SECTION I CHARACTERISTICS
CENTER FIRE RIFLE
S.A.A.M.I TECHNICAL COMMITTEE MANUAL

PAGE 1493
CARTRIDGE & CHAMBER
30/06 SPRINGFIELD
APPROVED S.A.A.M.I. 1-22-17
11/7/17
CHAIRMAN TECHNICAL COMMITTEE
ISSUED S.A.A.M.I. 3-1-59

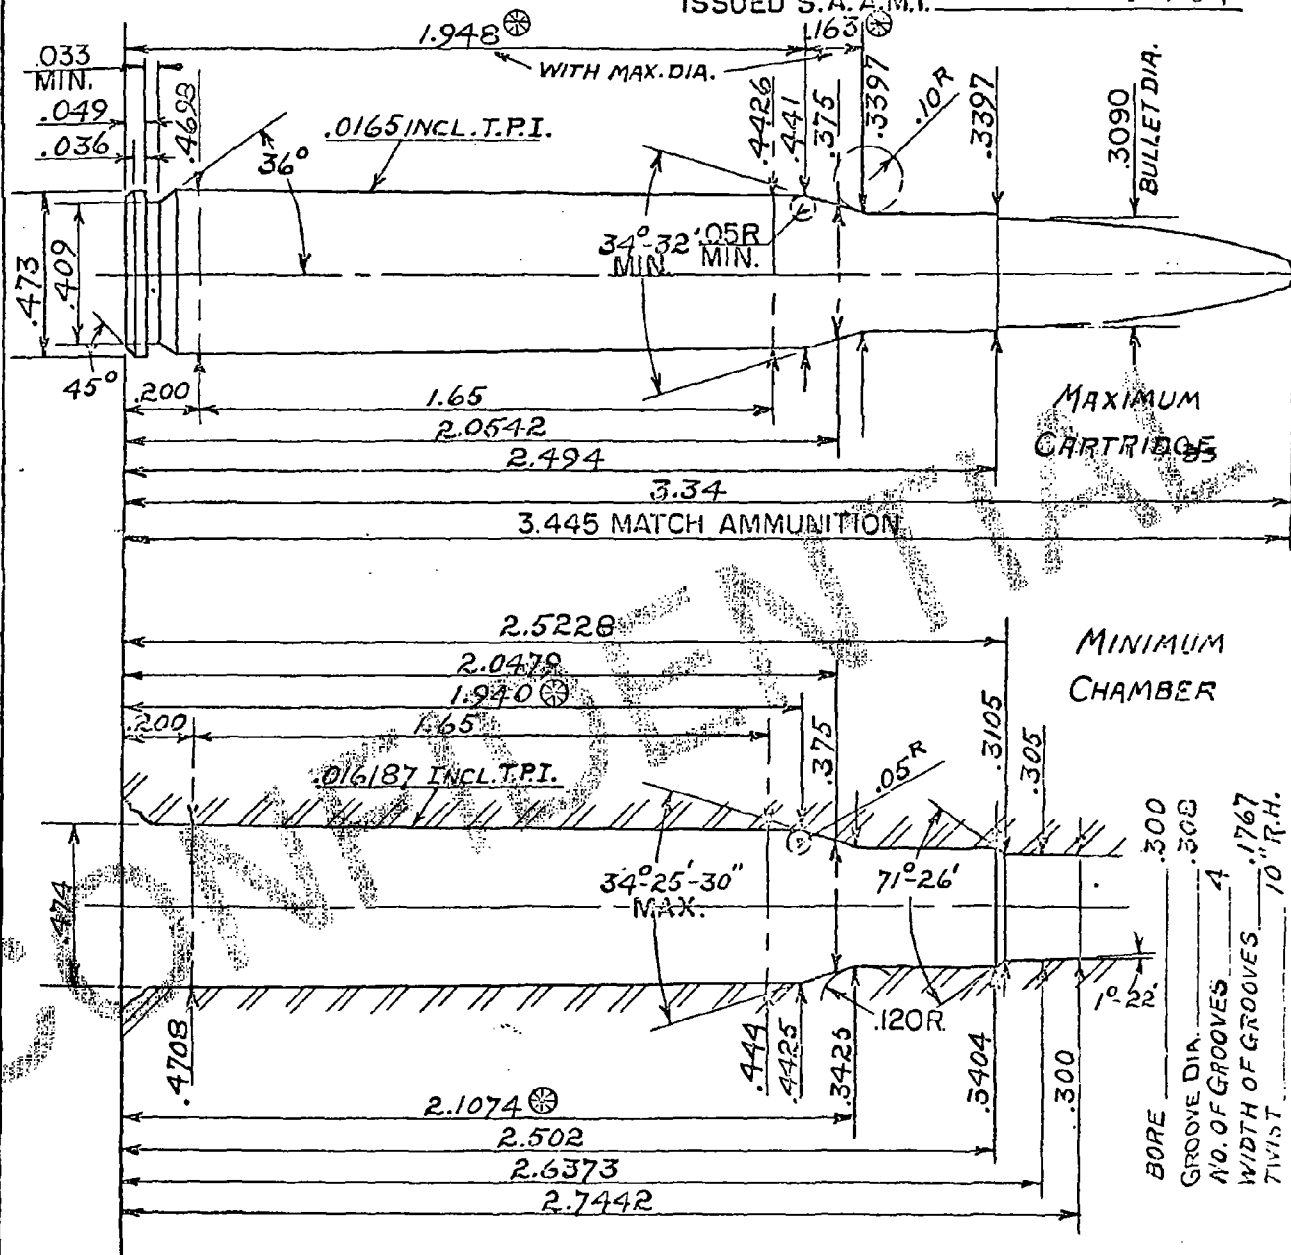
REV.	DATE	C/M No.	REV. BY	APPROVED BY	DESCRIPTION	CHECKED BY	CAL. 30/06 SPRING.
1					NEW DRAWING - SUPERSEDES		MOD. RIFLE
2	6/7/48		QAR	M.A.R.	120 WAS 120 - 300 WAS 2799	QAR	
	83156		J.W.		3090 WAS 3085 BULLET	J.W.	APPROVED
	83156		J.W.		033 MIN. WAS .037	J.W.	
	102456		J.W.	SUB COMM.	05R MIN. WAS .04R	J.W.	DATE JAN. 22, 4
	5763		J.W.	SUB COMM.	ADDED 3.445 MATCH AMMO	J.W.	S.A.A.M.I.
	93066		J.W.		120R WAS .24 DIA.	J.W.	DRAWN QAR, THACED QAR, CHECKED QAR
	10-1-60			B&D	New pg. No. (was 1480)		ISSUED BY TO
